Superformance S1 Roadster Service Bulletins and Technical Service tips

S1 Technical Service Bulletins quick reference

S1 Service Tips quick reference

Fig. 1 Latest fender attachment used by Superformance.

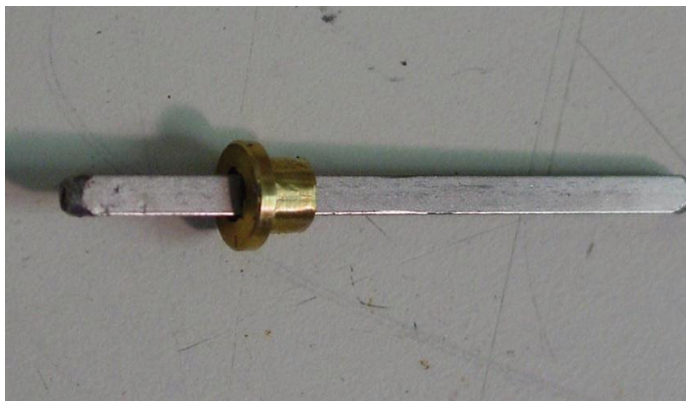
This bulletin details problems that have been encountered with the early S1 concerning the fender loosening. If the fender loosens up at the bracket there is a good chance that the bolt head will shear off and cause the fender to drop. If your car already has chrome acorn nuts on the backside of the fender attachment points, your car has already been modified. If you have the acorn nut and your fender has loosened, you should tighten the Allen bolts inside the fenders.

The fix at this is the upgraded bolt setup used now by Superformance *Fig. 1*. The following instructions will allow you to repair the car with the same size bolts used by the factory. Plain metric nuts can be used temporarily and we can supply the chrome acorn nuts that can be swapped in at a latter time. We recommend that you make these modifications now, to avoid any damage to the fenders. If it is convenient for you, Snakebite can make this repair for you.

You will need four 4 centimeters long, 8 mm - 1.25 bolts with a 1 to 2 centimeter shank. Four 8mm - 1.25 chrome acorn nuts (or lock nuts) and four lock washers. We can provide this hardware for you if needed. You will also need a 17/64; a 5/16 drill bit and a 8mm -1.25 tap to modify the bracket.

Start by removing the wheel and remove the original 6-mm bolts attaching the fender to the brackets. The modification can be done on the car but you may find it easier to remove the bracket from the spindle.

Drill out the 6-mm hole in the bracket all the way through with the 17/64 drill bit. Next drill into the hole from the fender side about half way through with the 5/16-drill bit. Tap the hole with the 8-mm tap. Repeat on all four-support brackets

Open up the holes in the fender with the 5/16-drill bit.

Use the 8-mm bolts to attach the fender and tighten securely. Install the lock washer and the acorn nut on the backside of the bracket holding the bolt as you tighten. *Fig. 2*

S1 Bulletin: 0202sb Speedometer shows no speed.

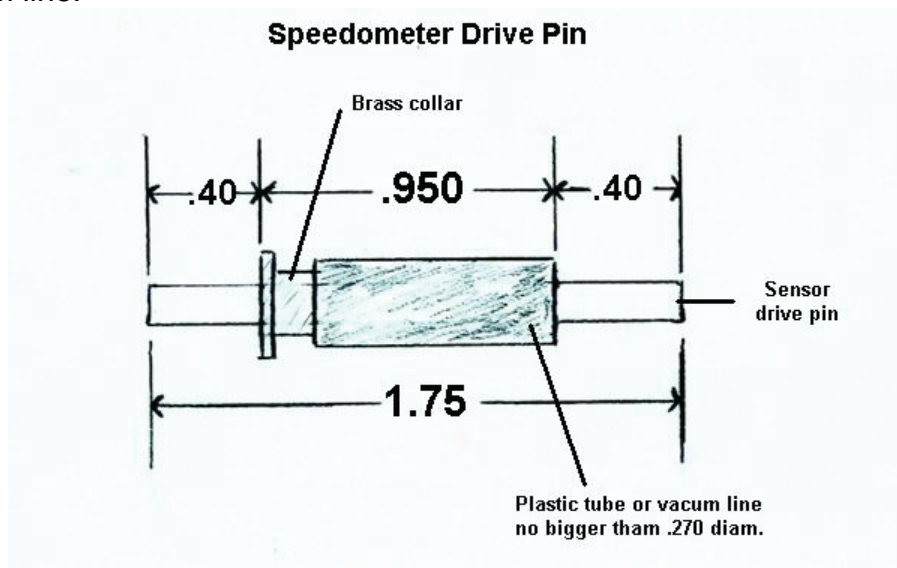
The speedometer sensor drive pin shown above, has been found to walk out of the sensor, causing the above-mentioned problem. To prevent this from occurring, a small sleeve can be made from plastic or a vacuum line.

Fit the sleeve as shown above. Insert the pin, brass collar towards sensor. This will prevent the pin from walking out.

Figure 1 Original Mount

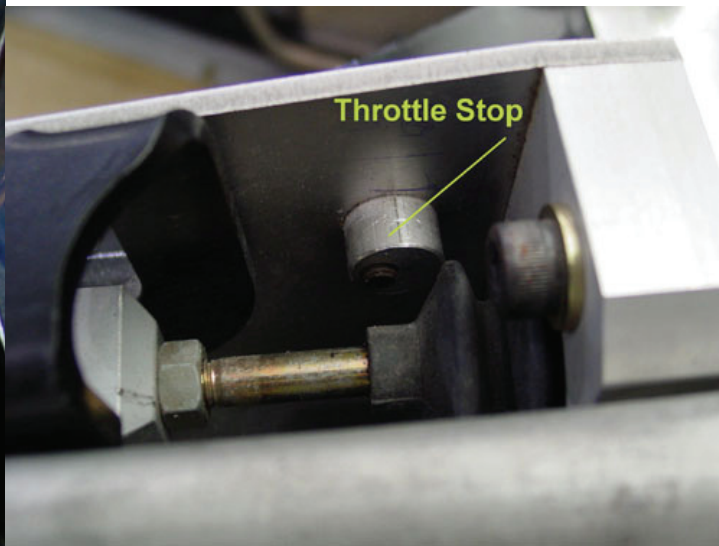
Originally the S1 windshield was attached to the frame with a pedestal type mount. This mount was causing alignment problem during assembly. To align the windshields, washers were used to shim the pedestal. (See fig. 1) This proved to be an insufficient adjustment. A production change occurred around car #18, to a mount, with a pivoting adjustment point. After adjustments were made the bolt would be tightened and the pivot welded. Some cars got through without being welded. (See fig. 2) You must first check under the dash on either side to see which mount you have. If you have the early mount (See fig. 1) you will have no problems. If you have the later one with one large bolt in it, (See fig. 2) check to see if it is welded or has a second smaller bolt. If not it will need to be repaired.

First thing to do is reposition the windshield frame if it has moved out of place. You will want to push the frame far enough forward to close the gap in between the frame and cowl. When you have the frame where you want it you may need to have a helper hold it in position while you tighten the large bolt on the mount. You will need a short 19mm wrench to hold the nut in the back. After getting these bolts as tight as possible the frame should stay till holes are drilled for second bolts. Drill a 5/16 hole at the bottom rear corner of the mount. If drilled at the spot pictured, (*see fig. 3*) there should be no chance of drilling through and hitting the outer body since there is a ledge in the frame, that can be seen in the pictures. Secure the mount using a 5/16 bolt and lock nut. Do this on each side.

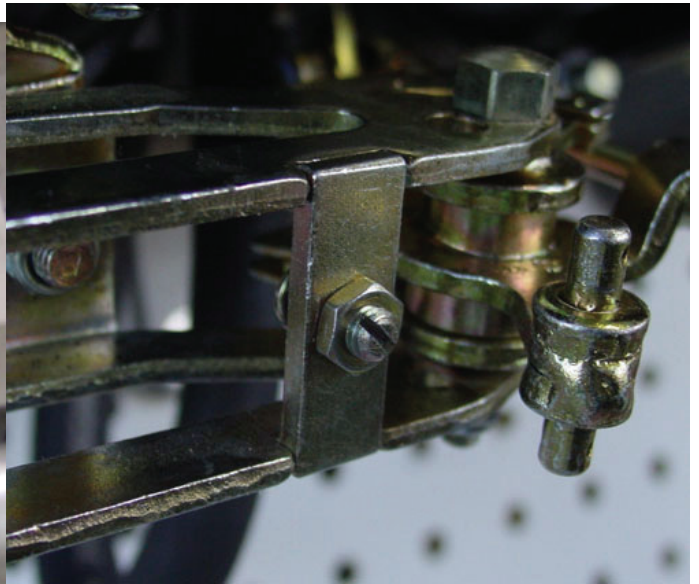
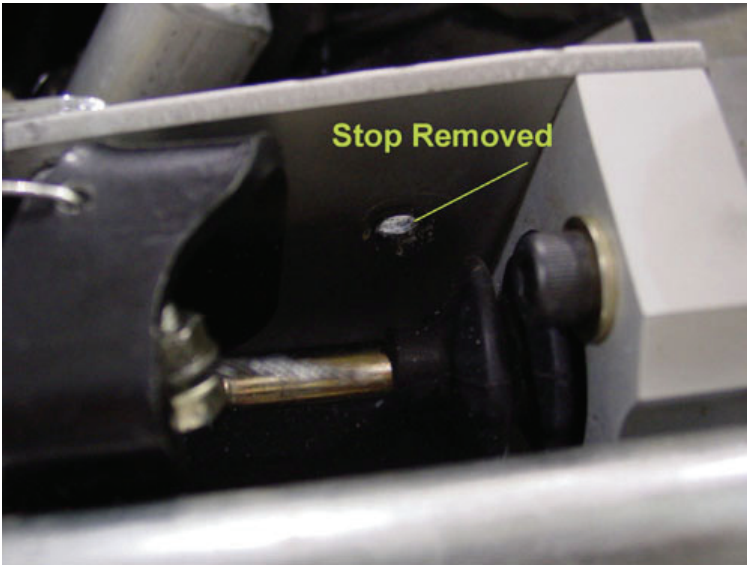
As shown above, with the pedal to the floor, this is the most throttle opening we had. The problem was the factory throttle stop shown to the right.

Fortunately the Alpha system incorporates it's own throttle stop on the bell crank bracket and the factory one can be eliminated.

To remove the factory stop you will need to hold the aluminum barrel with a vice-grips or pliers and loosen with a 3mm Allen wrench.

With the throttle stop removed have someone fully depress the pedal. On the throttle bodies, look for the lever stop, a small screw locked in place with a small nut. (Shown above) The lever should come in close contact with the back of this screw. Adjust the screw to make contact with the lever at full throttle. Check that the plates are fully open. You may need to adjust the linkage rod, off of the lever, to achieve this. In extreme cases if the lever will not reach the stop a longer screw can be used (5mm 0.9) being sure to lock nut it in place. Below, we put the lock nut on the back side.

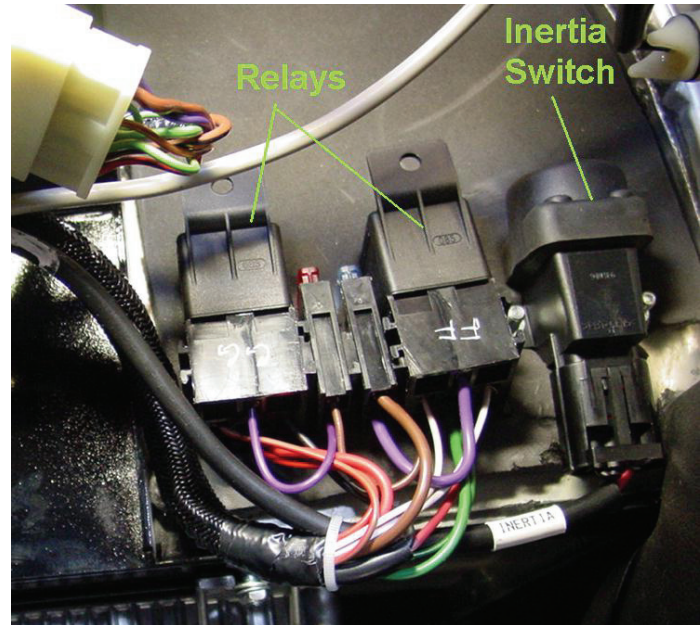
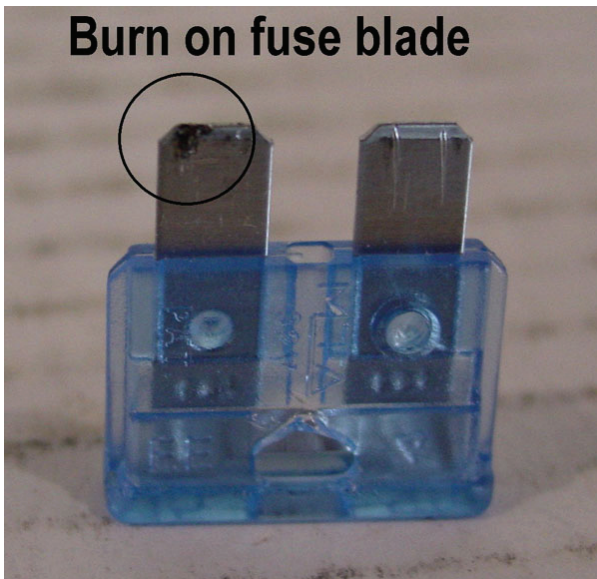
The loose spade can be seen here protruding from the back of the fuse holder. As the weak connection heats up the spade expands and loses its grip on the fuse or relay. The increase in resistance causes the fuel pump to lose voltage and the fuel pressure drops off until the car dies.

The burn on this fuse shows the break down of the connection at the spade connector. This car would operate fine for about 20-30 minutes then the fuel pressure would drop to about 18 psi causing the engine to stall. After an hour of sitting everything would return to normal.

Fuel pump and ECU relay mounting location is shown in the above right photo, behind the glove box, under the dash on the passenger side. All wires at the fuel pump and ECU relay and fuses holders should be checked for protruding connectors. If a loose connector is found, remove the fuse or relay, bend out the tab on the spade connector and reinsert it into the holder. Pull gently on the wire to make sure it is seated. If the fuse or relay is burnt it should be replaced.

Fig. 1

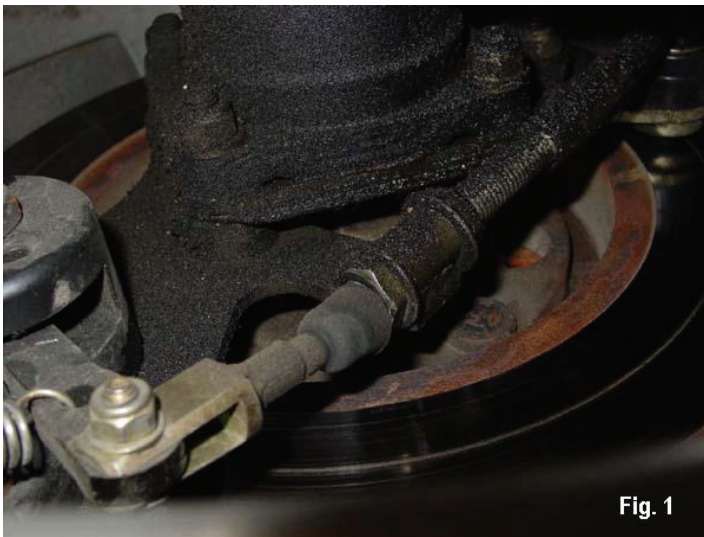
Some cars have been experiencing a leak at the axle tube ends that seems to be a seal leak. The end of the tube behind the brake will become soaked with fluid and can even be thrown onto the wheel. See *Fig. 1*

This leak is not the seal, which is part of the bearing, but fluid leaking around the wheel bearing. Repairing this leak takes about 45 min. per side and requires only a RTV type sealant. We highly recommend "Permatex Right Stuff"®.

Flipped link, trunk side view.

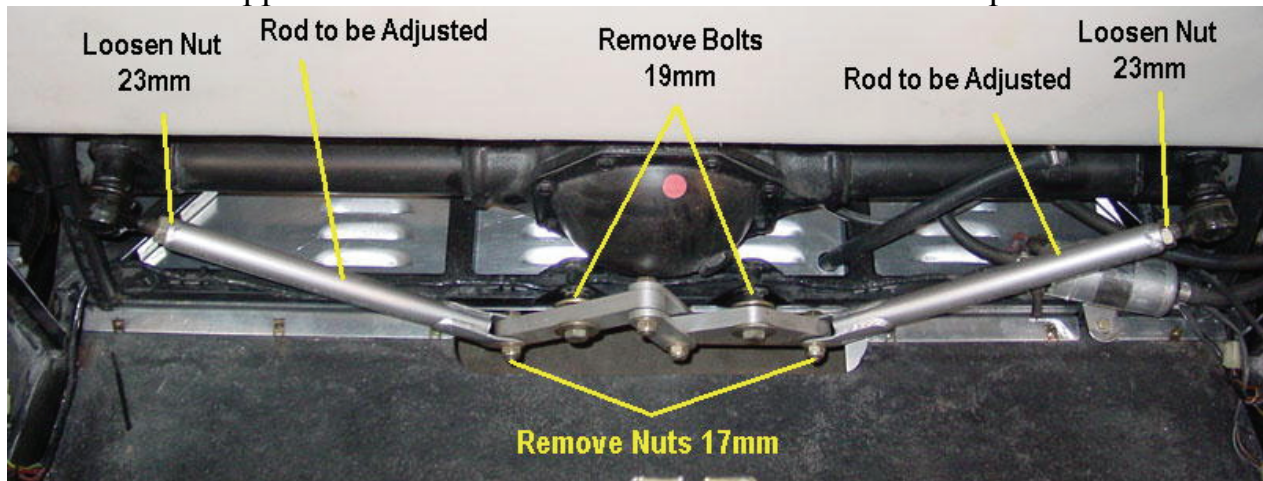
It is advised that any cars numbed 36 to 60 range be checked for a flipped Munford link on the left side. (See photos below) If your car is in this range and the link looks normal, be aware that under extreme driving or a severe hard bump the link could flip. The following adjustments can eliminate this as a problem. If the link becomes flipped it will have little effect on driving and is not dangerous.

A flipped link can be identified as shown in the above photos.

To make the adjustments, the rods shown above will needed to be lengthened. Because of the difficulty in removing the tie rod end, it is easier to unbolt the center pivots to make the adjustments. The above photo shows the wrench sizes needed to performer this adjustment.

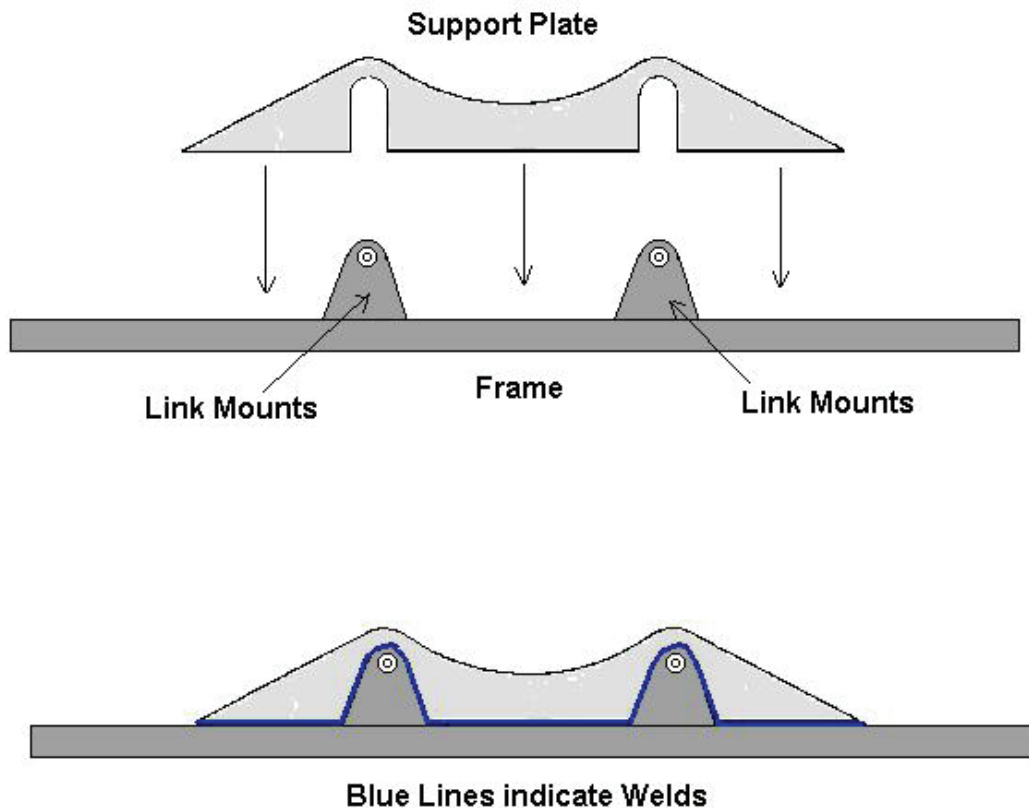
This reinforcement plate can be added to stiffen the S1 Munford link mounts. This area of the frame can be under high stress loads during racing and high speed cornering with race tires. Adding this plate is meant to distribute this stress over a wider area and keep flexing to a minimum. This plate is recommended addition to cars being raced on a regular basis. This installing will require a steel plate to be welded to the frame. This should be done by a competent welder, fabricator.

The brace has been designed to slip down over the Munford link mounts and contact the horizontal cross frame.

This brace should be welded as indicated above on the front and rear side where possible. Repaint area and reinstall the link.
